## **Corrigendum-01 dated 24.02.2023**

**Bid for Request for Proposal (RFP) for the Selection of a System Integrator for implementation (Design, Build, Commission and O&M) of Greenfield State Data Centre (Bid Number: GEM/2022/B/2889326 Dated: 22-12-2022)**

# Corrigendum cum Clarifications document

**Gujarat Informatics Limited (GIL)**

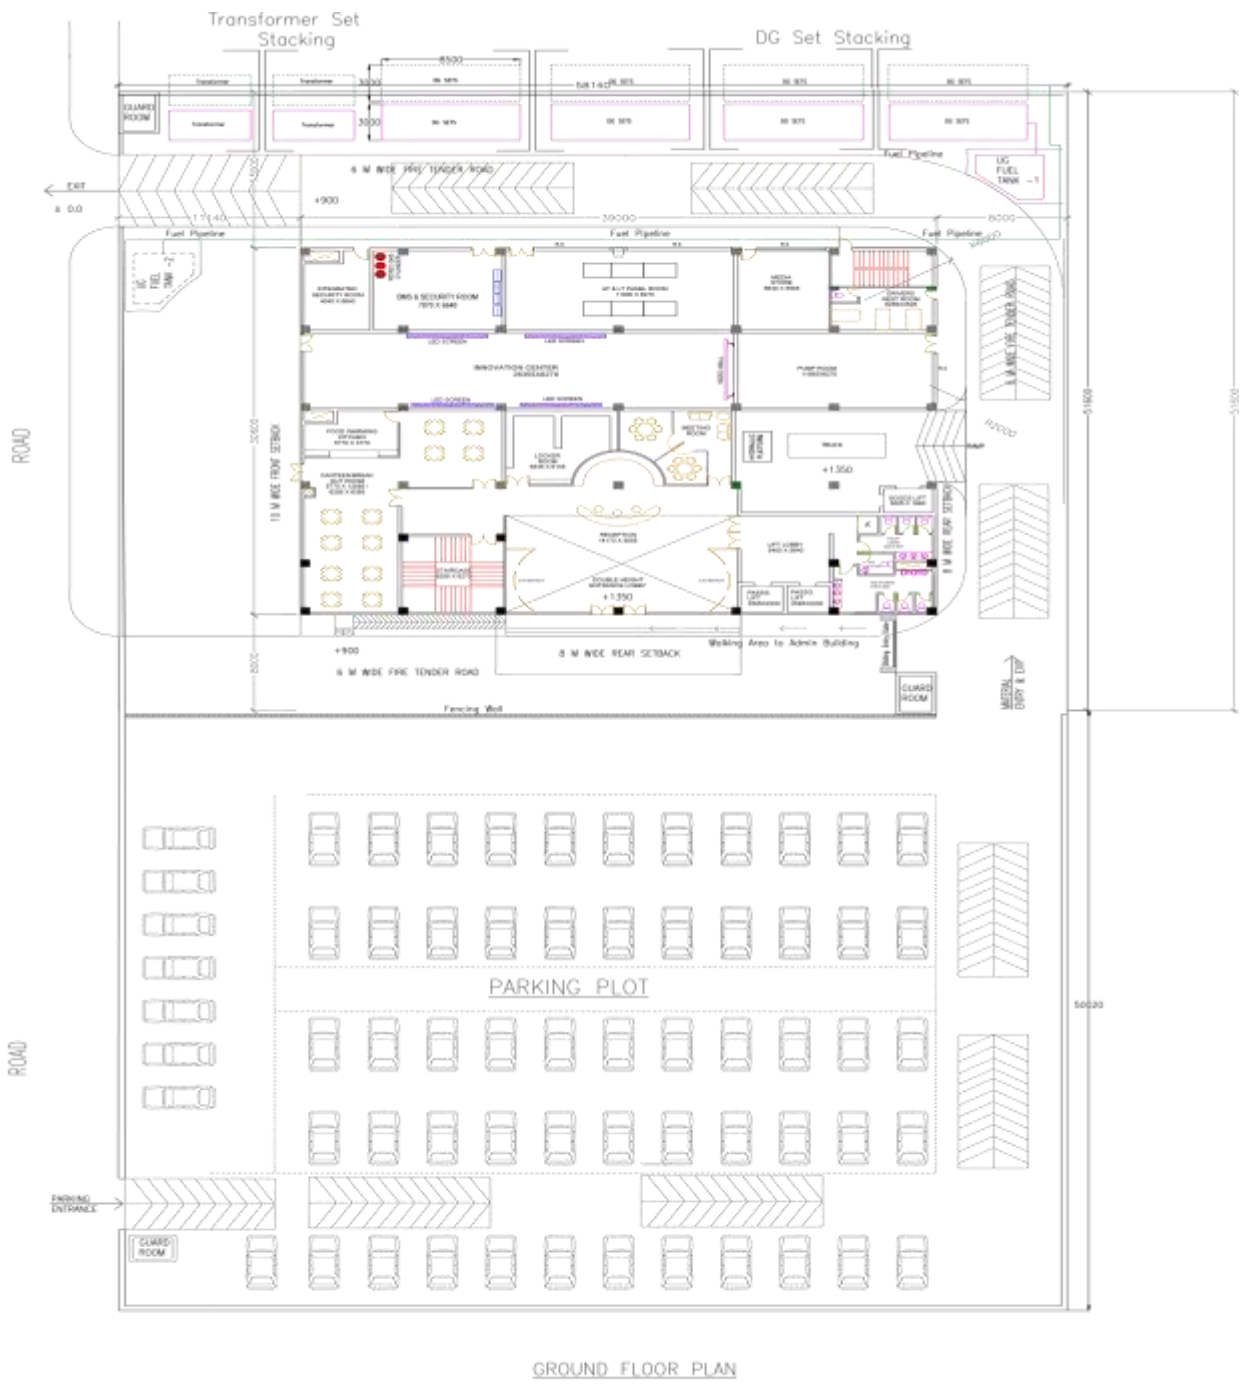
Bidder to consider proximity of car parking to data center perimeter building with physical barriers to prevent vehicles from driving closer.

Steel Fabricated gate to be considered at entrance & exit of the parking plaza. Bidder to submit layout drawings to committee for approval. All services drawings require to be integrated and all services plotted on single master drawing.

Illumination of parking area require to be considered with energy saving concept like sensor base for ON/OFF purpose, also perimeter Illumination require to be considered to be work on sensor base. All the non-essential area illumination like parking spot lighting, perimeter lighting, EV charging point, garden/ landscaping bollard fitting etc. to be considered on Solar power only.
